Proposed Amendments to the Jersey Avenue Park Redevelopment Plan Emerson District

November 3, 2016

Jersey Avenue Park Redevelopment Plan Land Use District Map

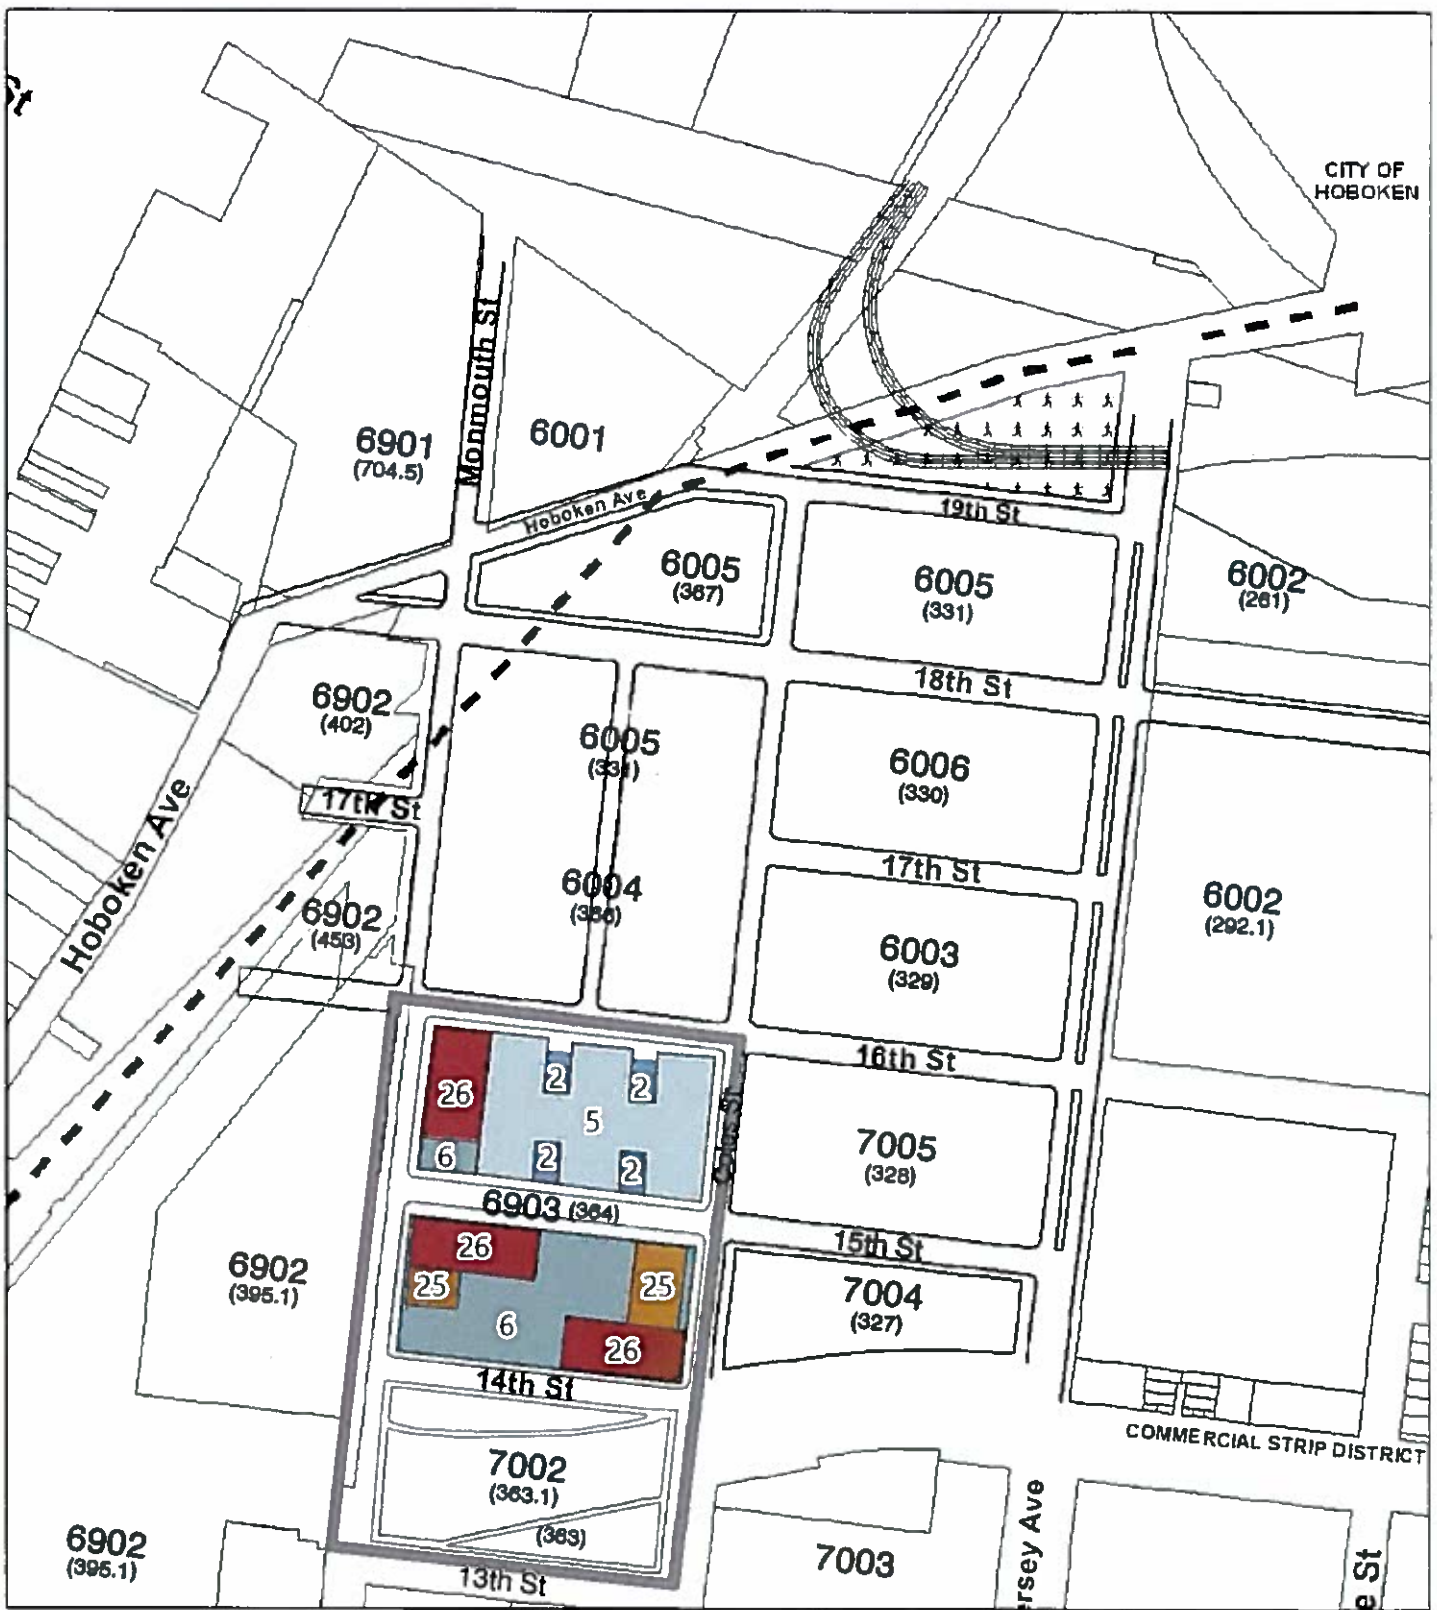
The boundary of the Jersey Avenue Park Redevelopment Area is presented on the ~~Redevelopment Area Boundary~~ ***Land Use District*** Map. The boundary of the Redevelopment Area can generally be described as beginning at the intersection of the centerlines of Hoboken Avenue and Jersey Avenue to the north and continuing south along Jersey Avenue to 14th Street, thence turning southwest along 14th Street to the centerline of Coles Street, thence turning south along Coles to the centerline of 12th Street, thence heading west along the centerline of 12th Street to the centerline of Hoboken Avenue, thence following the centerline of Hoboken Avenue to the north and turning east until reaching the beginning point at the centerline of Jersey Avenue.

1. Development regulations for the Redevelopment Plan Area consist of two interrelated parts, land use district regulations and the Land Use District Map. The land use districts are designated as the Medium Rise District, the Mixed Use District, *the Emerson District* and the Commercial Strip District. The area at Monmouth Street between Seventeenth and Fourteenth Streets has been dedicated solely to the Newport Electrical Substation. Uses in this area shall be necessary or ancillary to the Electrical Substation function, and shall be reviewed and approved by the Planning Board. *Land within the substation area may also be utilized to re-open Monmouth Street to a 60-70 foot right-of-way width.*

Jersey Avenue Park Redevelopment Plan
 Emerson District
 Max. Permitted Heights Map

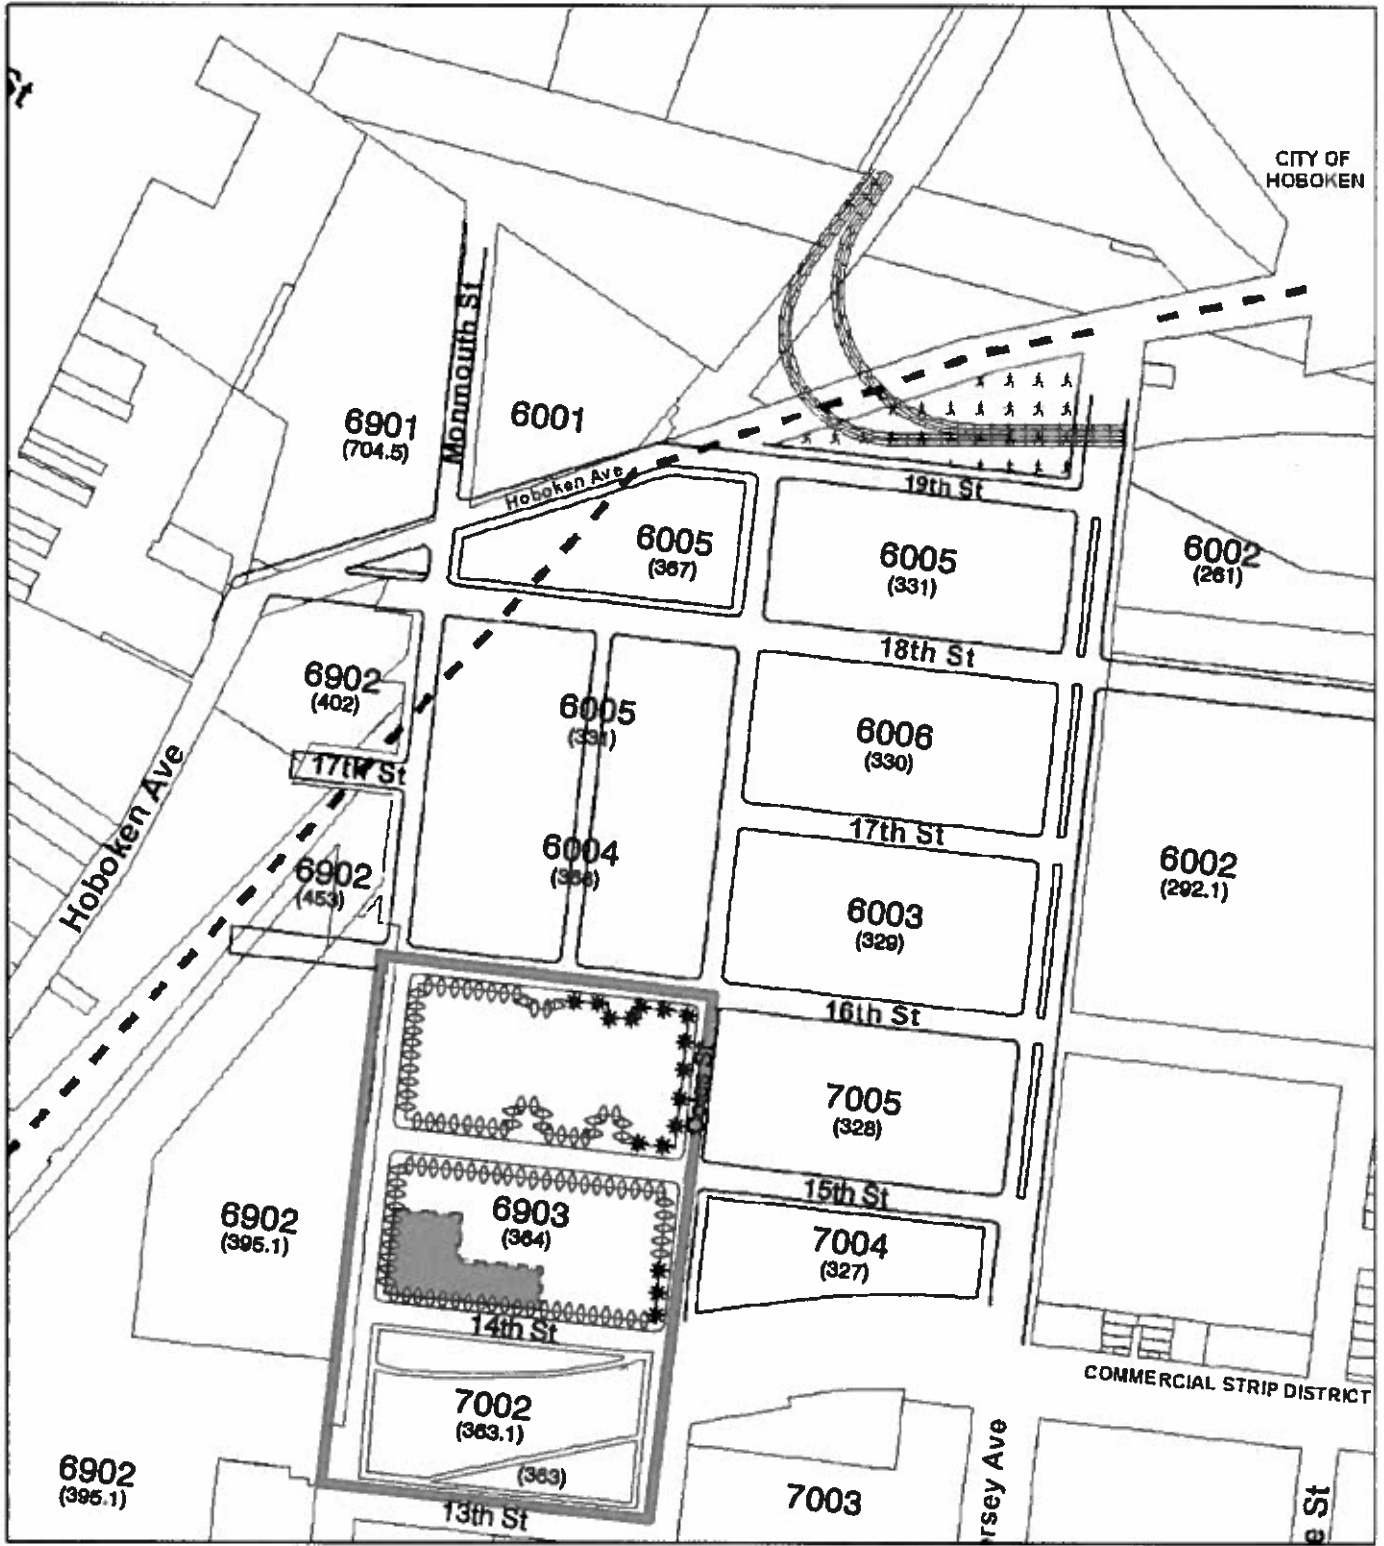
- a. *Building heights within this zone shall be as indicated on the proposed height map for the Emerson District and paragraph 8 of this section.*
- b. *That portion of the former Emerson Building to be retained and indicated on the Adaptive Reuse and Demolition Plan Map shall remain as a 5-story structure, although mezzanine or loft levels may be incorporated into the redesign of the interior of the building to accommodate the anticipated residential and commercial reuse of the building. No change to the apparent bulk or height of the retained building is permitted as visible from the adjacent rights-of-way.*

Jersey Avenue Park Redevelopment Plan Emerson District Ground Floor Frontage Map

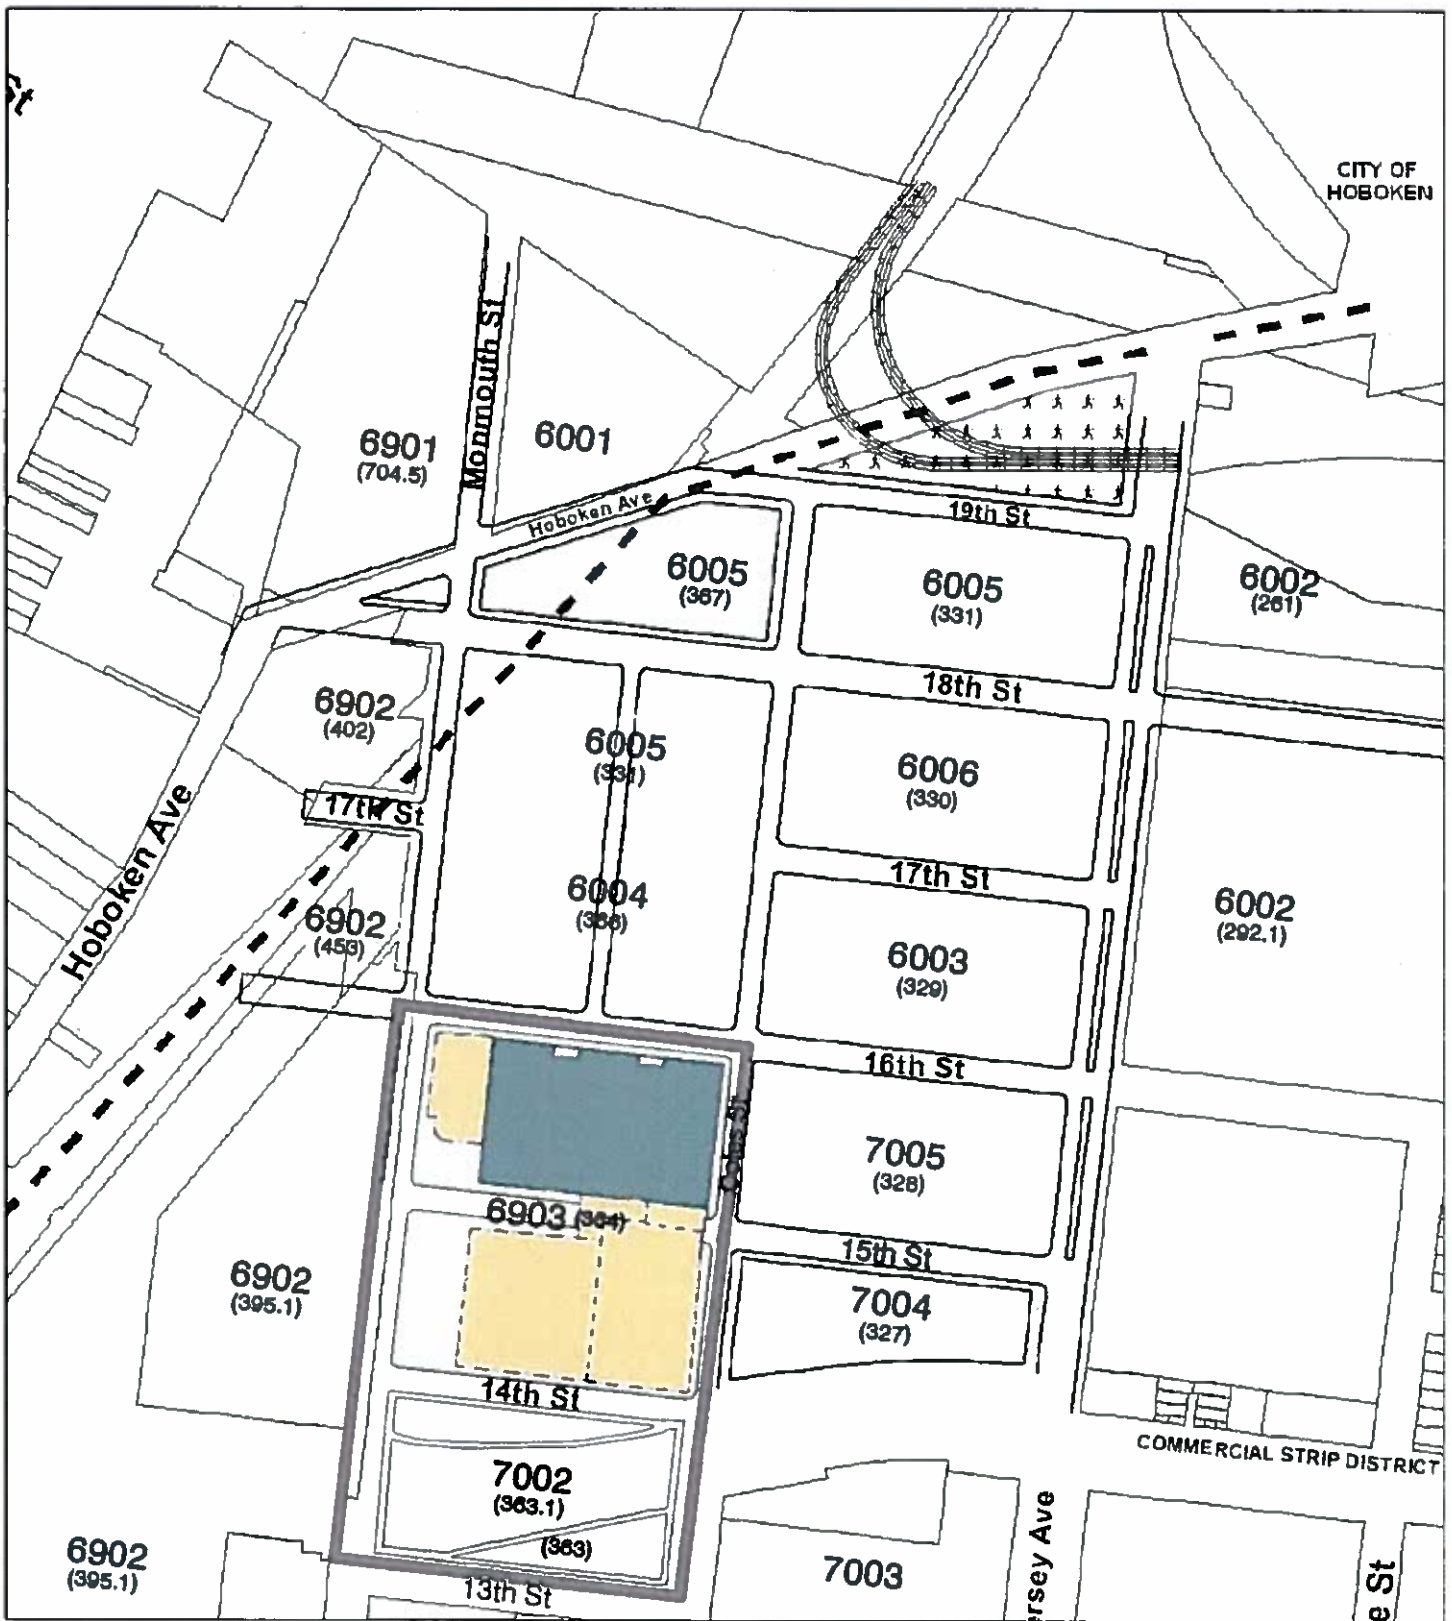
5. **Permitted Uses:** Please also refer to the Ground Floor Frontage Map for the location of Required Retail Frontages and other ground floor uses. The permitted uses in areas indicated as Retail Required shall be commercial uses that serve to activate the building frontages and streetscape such as Retail Sales of Goods and Services, Restaurants, Bars and Night Clubs, and other similar uses.

- 13. Public Use Facility Requirement -** *Subject to a Developer's agreement with the City of Jersey City, the redeveloper(s) shall construct and dedicate a shell space for a new Public Use Facility to service the Redevelopment Area and the community at-large. The shell space construction will include the concrete floor, windows, perimeter walls and roof of the enclosed premises and will include rough utilities to the space including water, gas, HVAC, sanitary and electric service appropriately sized for the square footage based on commercial use. The shell space shall be at least 20,000 square feet not to exceed 29,000 square feet and include a minimum of 40 easily accessible assigned parking spaces. This facility shall occupy a portion of the ground floor and may occupy a portion of the mezzanine level of the building identified on the Ground Floor Frontage Map. Before the issuance of any certificate of occupancy for this*

Jersey Avenue Park Redevelopment Plan
Emerson District
Adaptive Reuse and Demolition Map

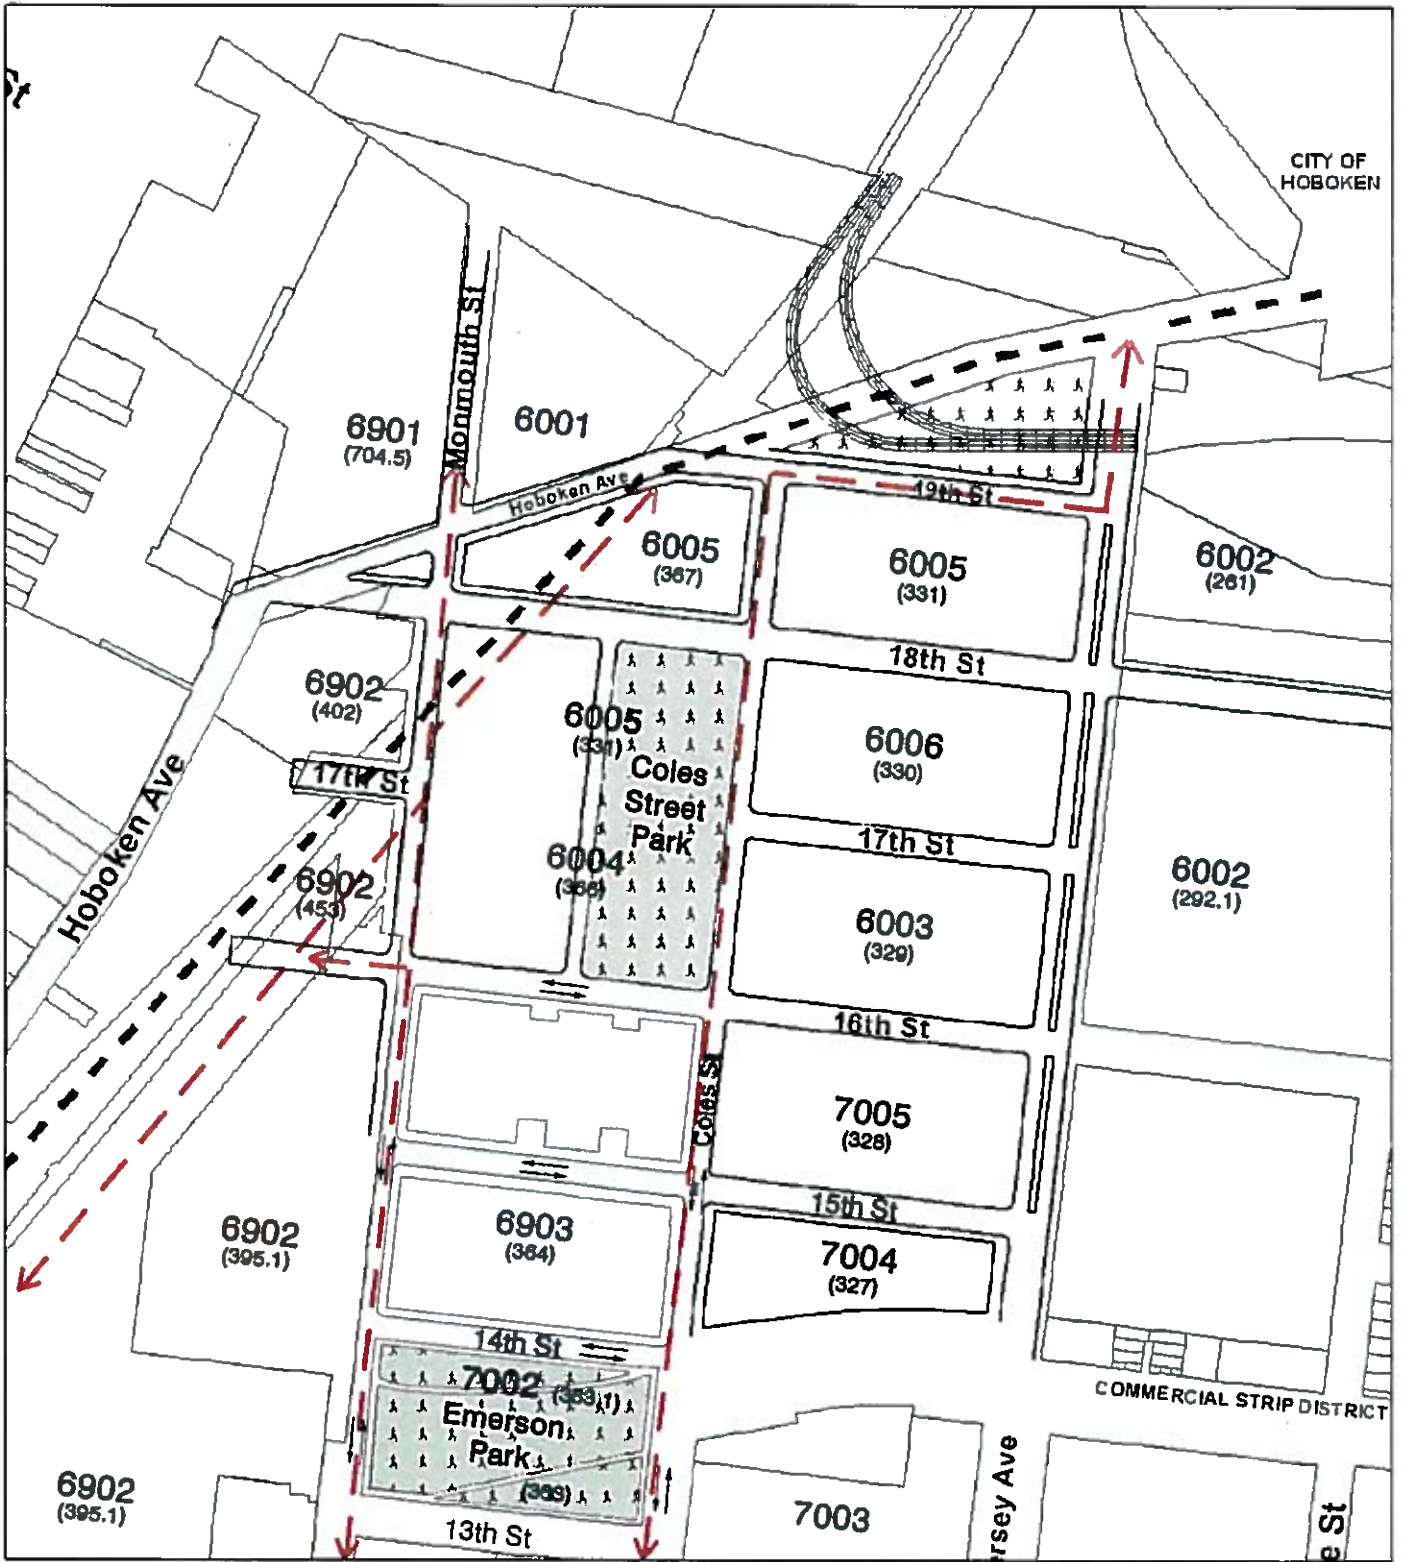
- a. That portion of the Emerson Building lying north of the former Fifteenth Street right-of-way shall be retained as indicated on the Adaptive Reuse and Demolition Plan Map for this Zone. Existing architectural features of the building are to be retained and restored. The rehabilitation of the northern portion of the Emerson Building shall be carried out in a manner that respects the industrial character of the existing building utilizing in-kind materials and finishes. Care shall be taken in selecting replacement windows, doors, and other materials in order to maintain the architectural style and industrial character of the structure. Replacement windows shall match the original size and have similar window patterning. Additions to the existing building, such as rooftop bulkheads and amenity space, and new buildings adjacent to the existing structure, may be done in a contemporary manner and with contemporary materials such as metal and glass to differentiate the new additions from the existing structure; while respecting the character and design of the existing building.*
